BUREAU OF LAND MANAGEMENT

IN REPLY PLEASE REFER TO:  
3482  
UTU-63214, UTU-47080  
(UT-923)

Re: SUFCO Mine - Minor Modification to Resource Recovery and Protection Plan (R2P2),  
New Sequencing and 4 West Development Areas

Enclosure:  
Approved Mine Map

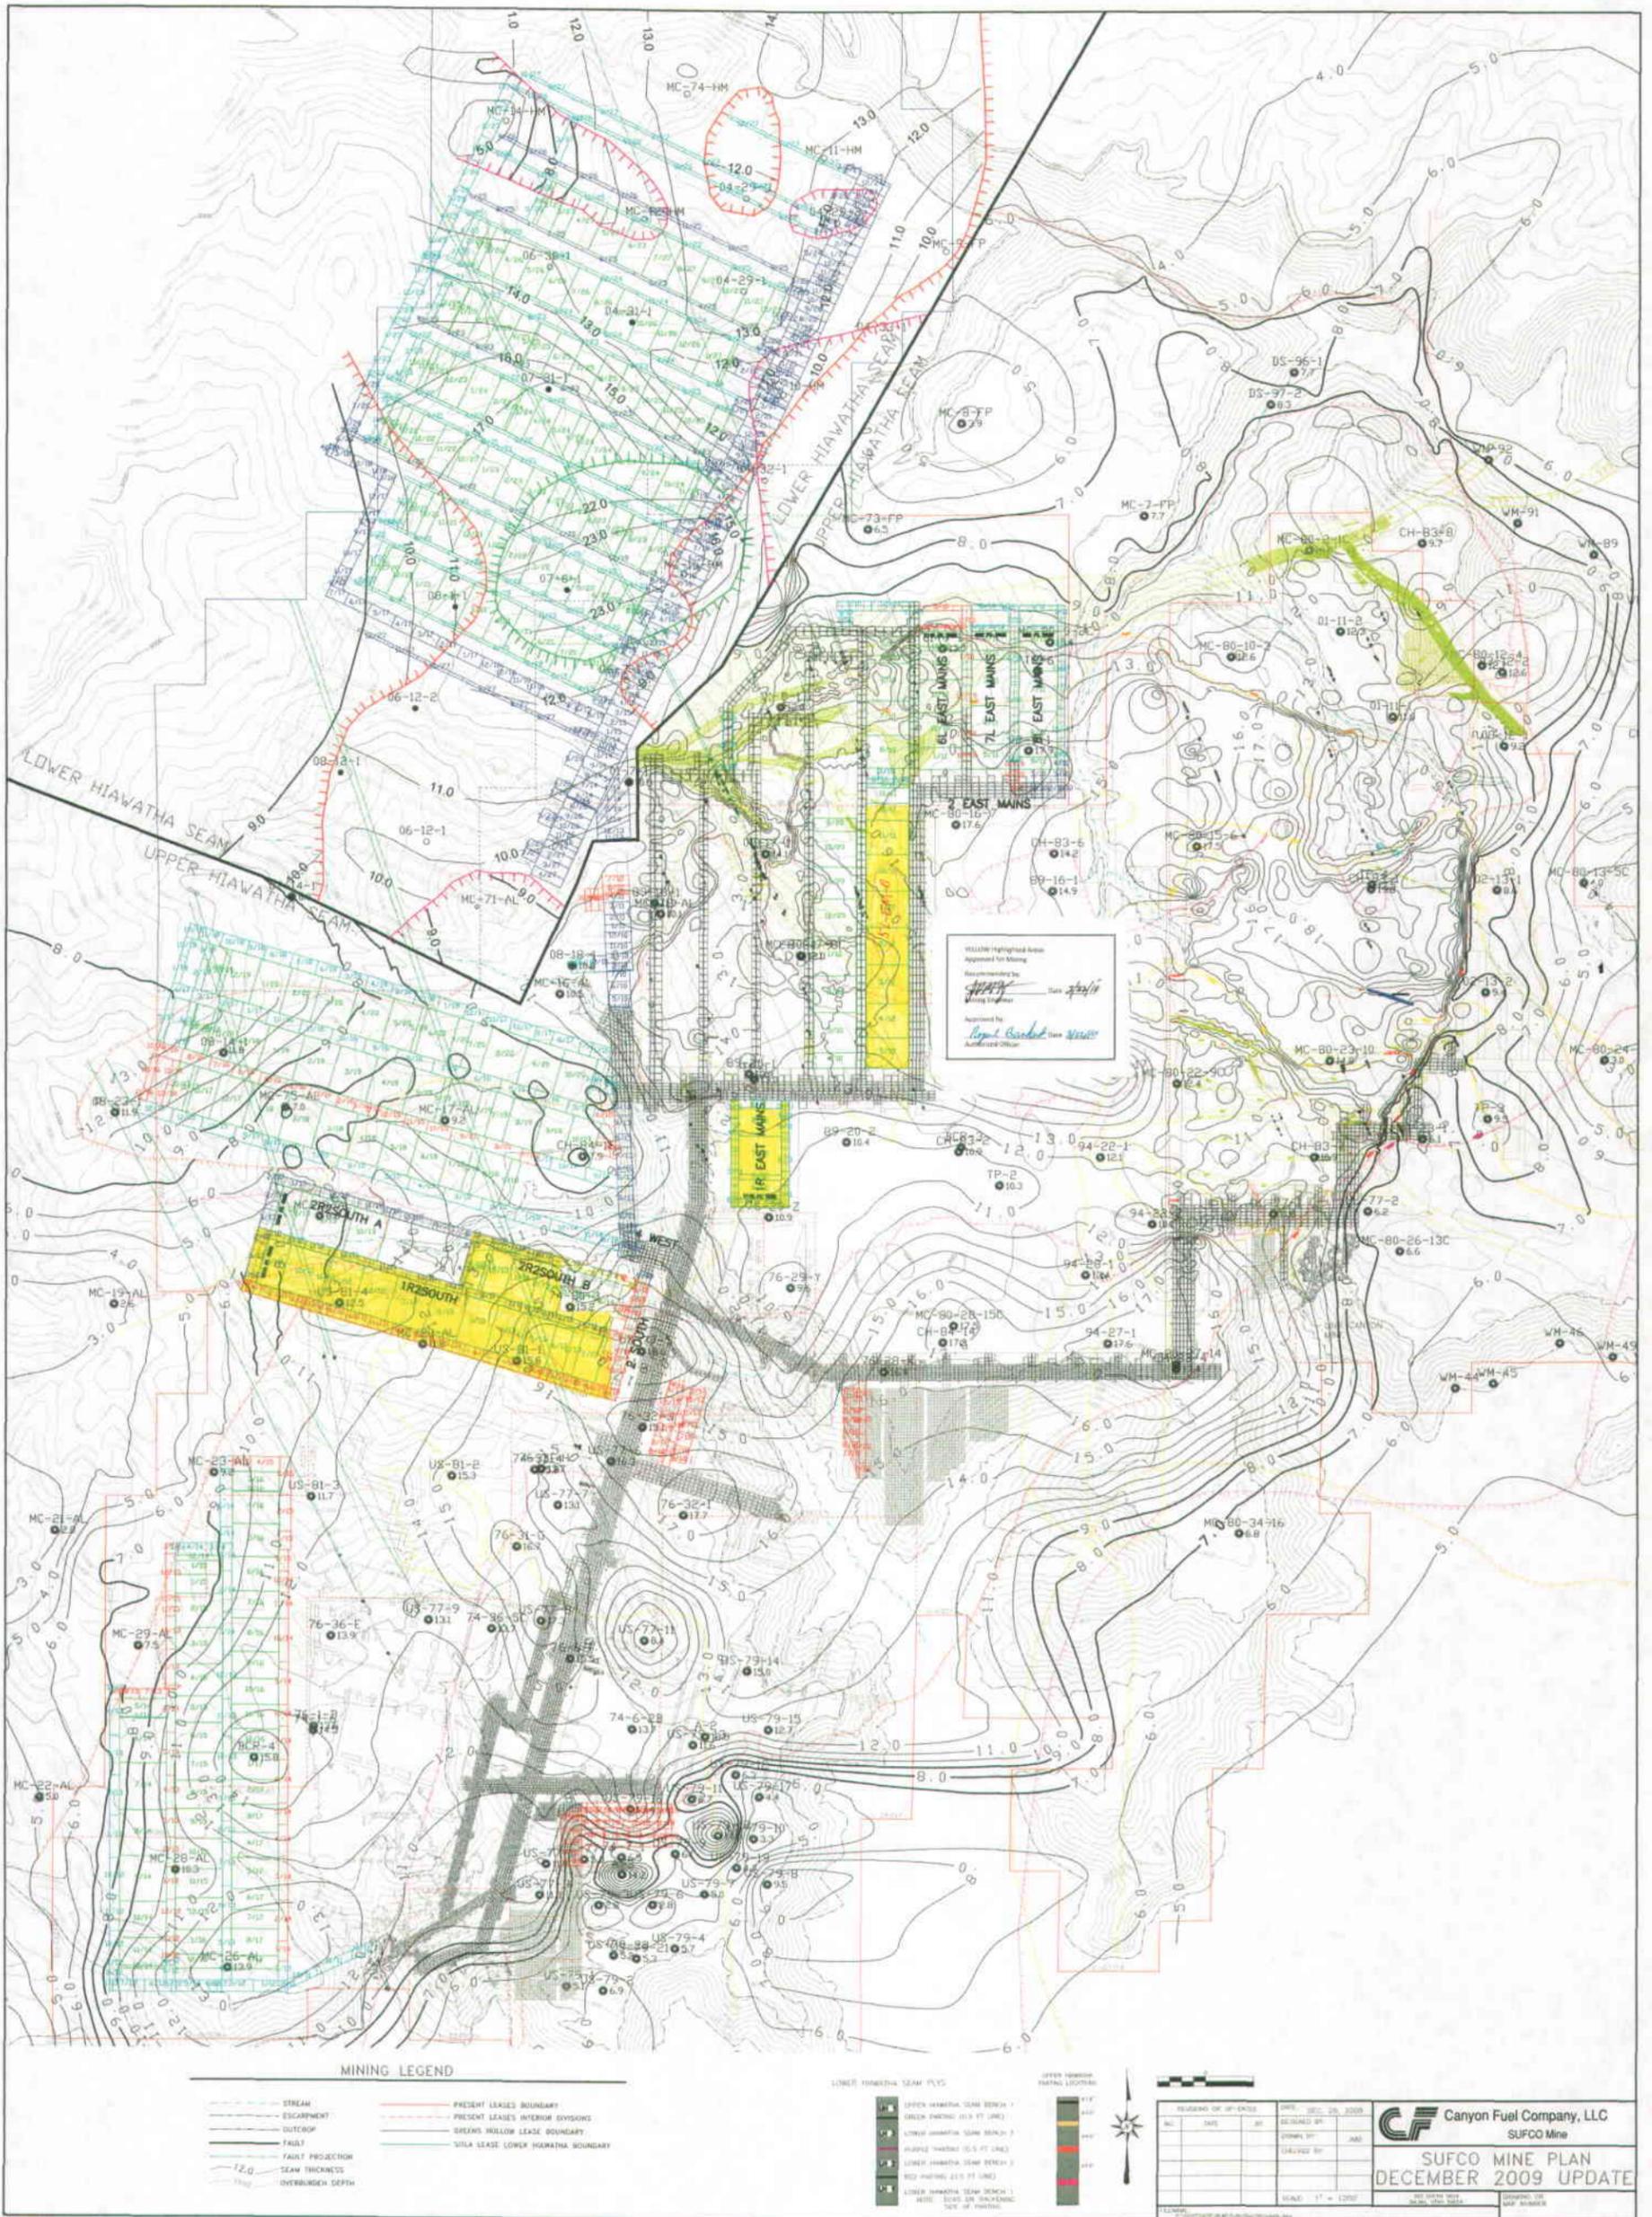
The plan modification includes the timing and sequencing of four longwall panels as highlighted on the attached approved mine plan. The four longwall panels are on Federal leases UTU-63214 and UTU-47080.

First: the Federal portion of the 5 Left-East Mains panel, continuation of the longwall mining in the panel -- on the map: "5L-EM-B"

Second: the remaining block of longwall coal in the East Mains district - 1 Right East Mains -- on the map: "1R East Mains"

Third and Fourth: Canyon Fuel projects development of the 2 South Submains off of 4 West (on Fee coal) and the corresponding two longwall panels to the west on Federal coal -- on the map: "1R2South" and "2R2South B"

BLM approves the mining of 5L-EM-B and 1R East Mains. BLM also approves the mining of 2R2South B and 1R2South, with the concurrence of the Fish Lake National Forest. These areas are highlighted on the enclosed approved mine plan. Maximum economic recovery of the Federal coal will be achieved as the plan is followed. Separate approval will be required from the State & Institutional Trust Lands Administration (SITLA) for SITLA lease ML-49443 at the SUFCO Mine.

Within 60 days of receipt of this letter, Canyon Fuel is required to submit a summary of the change in the recoverable reserve tonnage base to BLM for review and acceptance.
